City Engineer Recommendation Letter

DATE: April 25, 2023
TO: Melissa Anderson, Zoning Administrator
FROM: Ryan C. Kump, P.E., City Engineer
SUBJECT: **Project Name: 3802 Catamount Ridge**
Case Number: RES03132023-030241
Project Address: 3802 E Catamount Ridge

**Re: Planning Commission Review/Permit Application
3802 E. Catamount Ridge Way, Sandy, UT 84092**

SHEET NUMBER
C200
5 OF 10

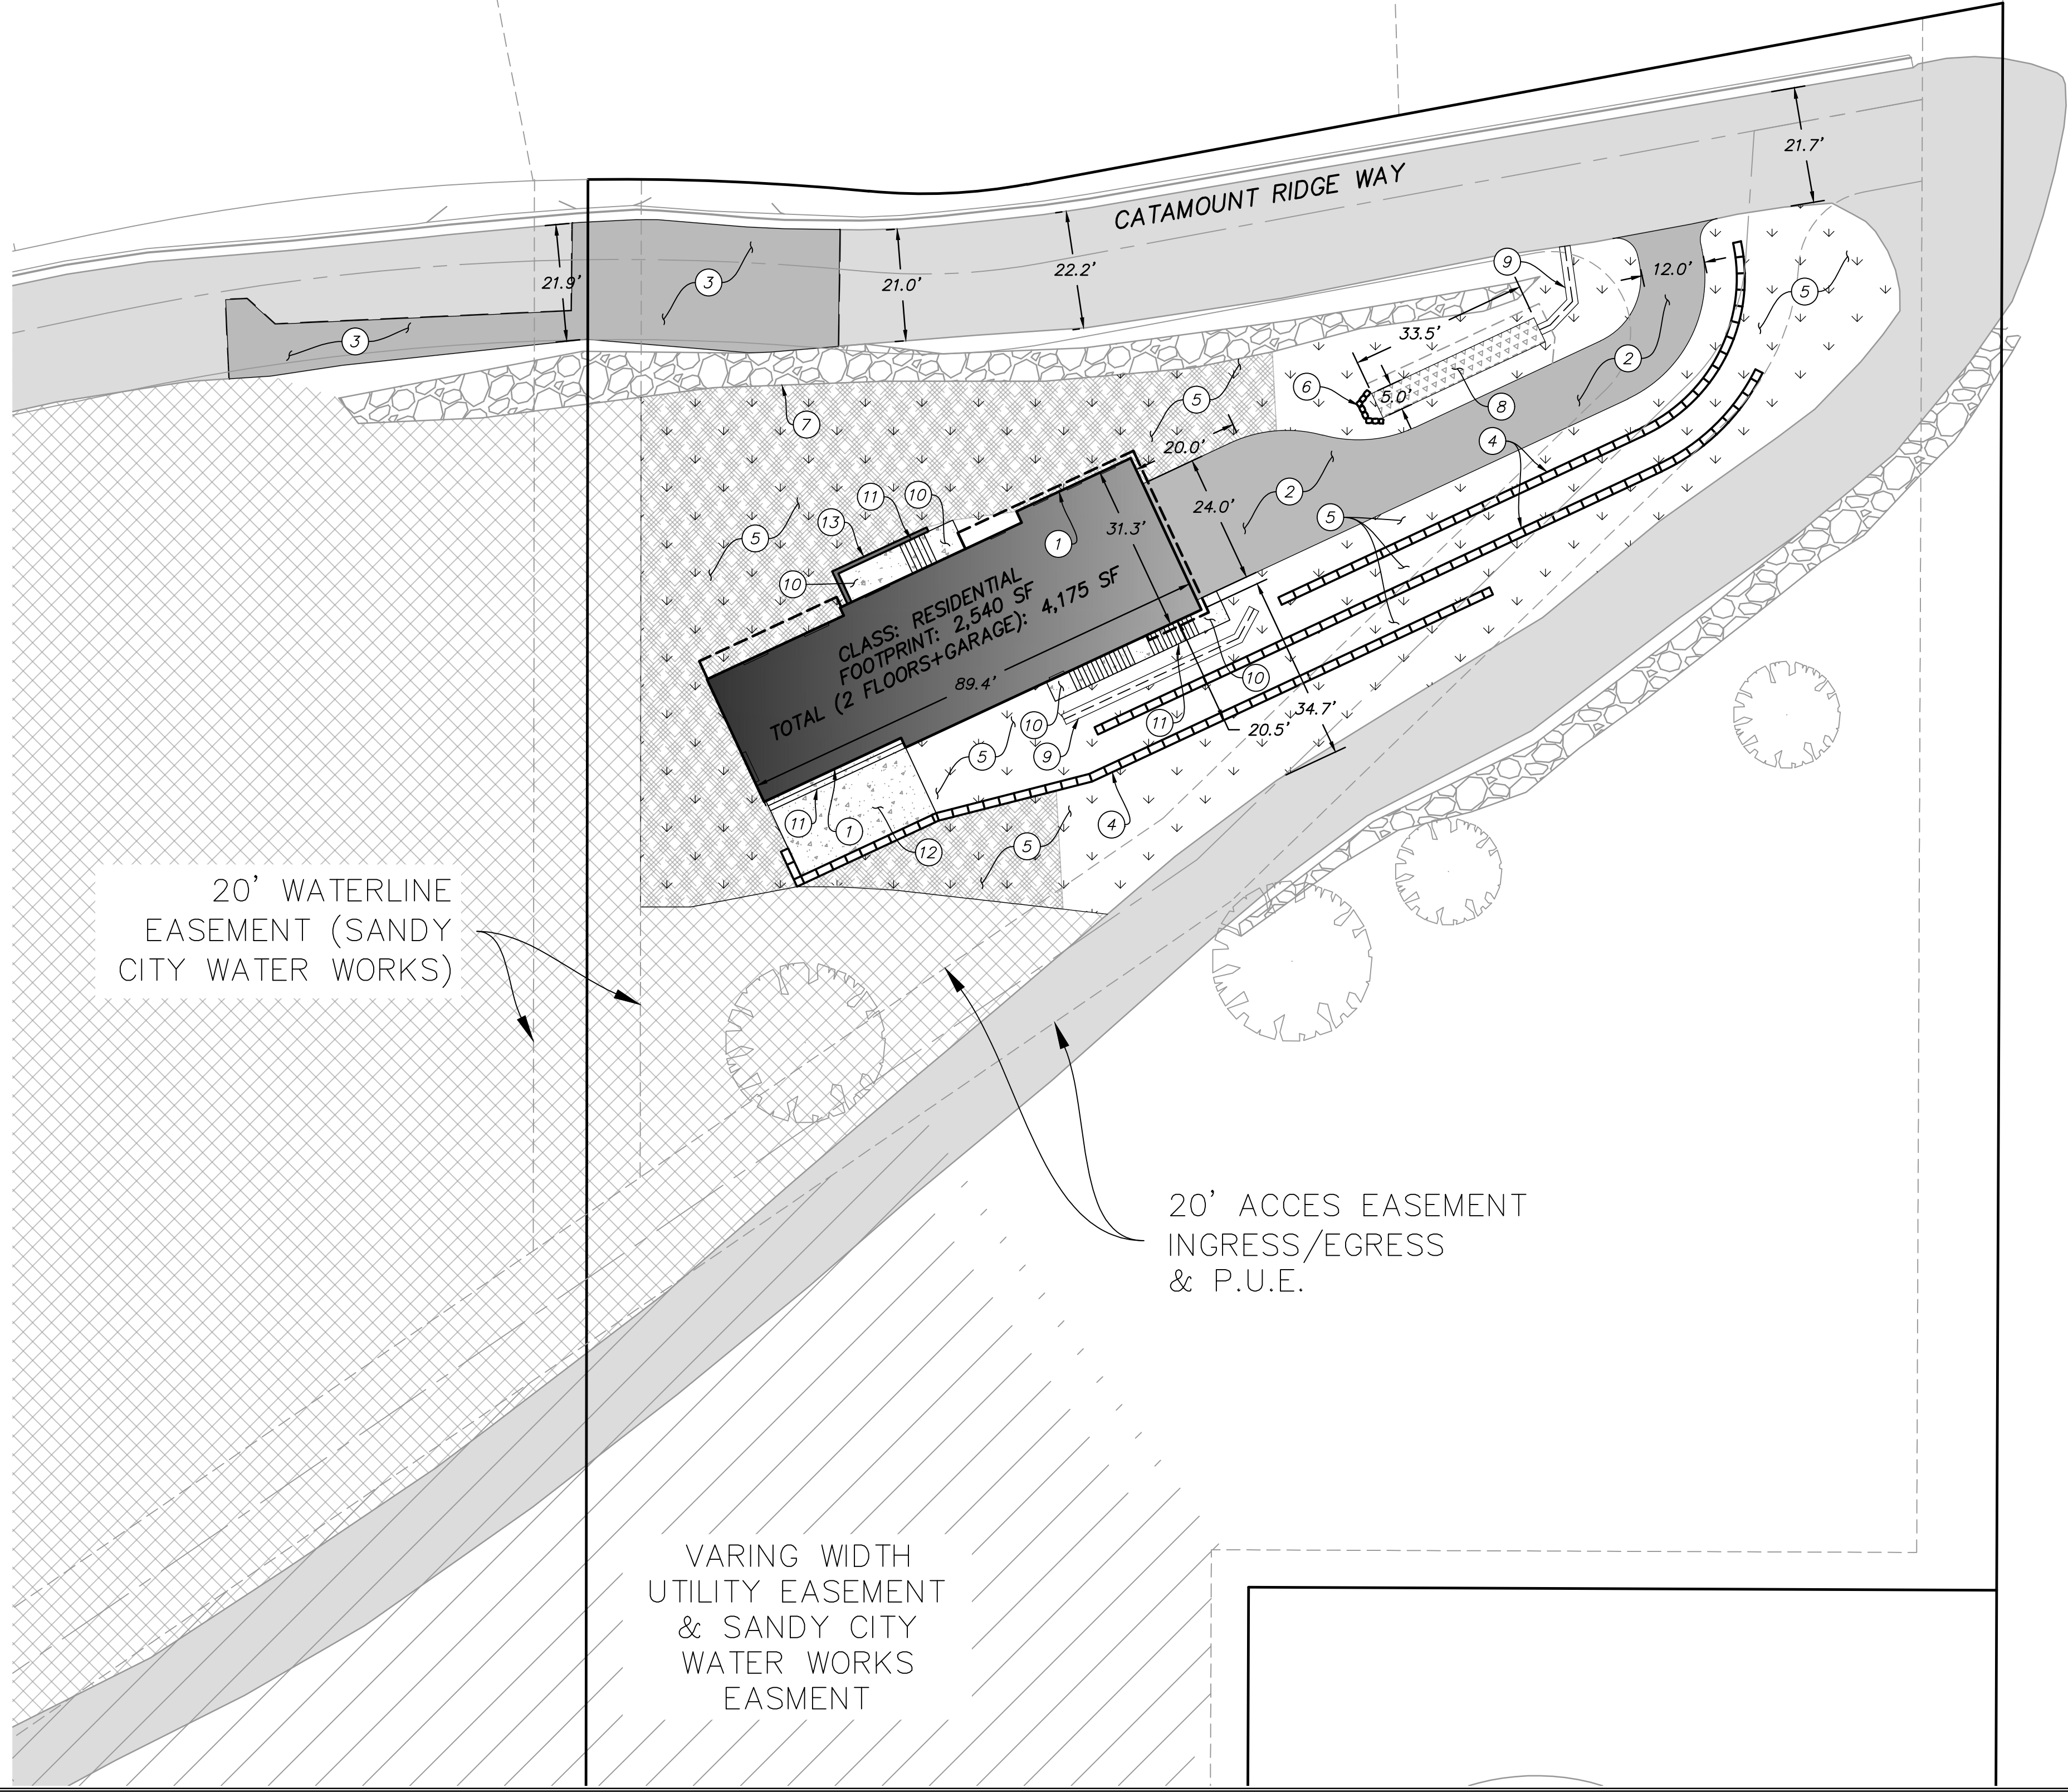
4. That a vegetation plan, in accordance with Development Code Section 21-15-4(b)(3) be reviewed and approved by staff prior to issuance of a building permit to ensure the disturbed areas of the lot are properly restored, and drainage and slope stability issues are mitigated.

- The Vegetation Plan, prepared by Focus Engineering and Surveying LLC, and the Site Plans, prepared by Talisman Civil Consultants, LLC address the requirements of Sec. 21-15-4(b)(3) (Vegetation and Revegetation).
- The table below listed the requirements of Sec. 21-15-4(b)(3) and comments on how these items are addressed in the submitted plans and will be addressed during site work:

Sec. 21-15-4(b)(3) (Vegetation and Revegetation):	Comments:
a. Vegetation shall be removed only when absolutely necessary for the construction of buildings, roads, and filled areas.	The submitted Site Plan (Sheets C100, C200) anticipates removing only the vegetation that is required to construct the residence, the driveway, and the retaining walls. The area of disturbance was previously reviewed and approved by the BOA.
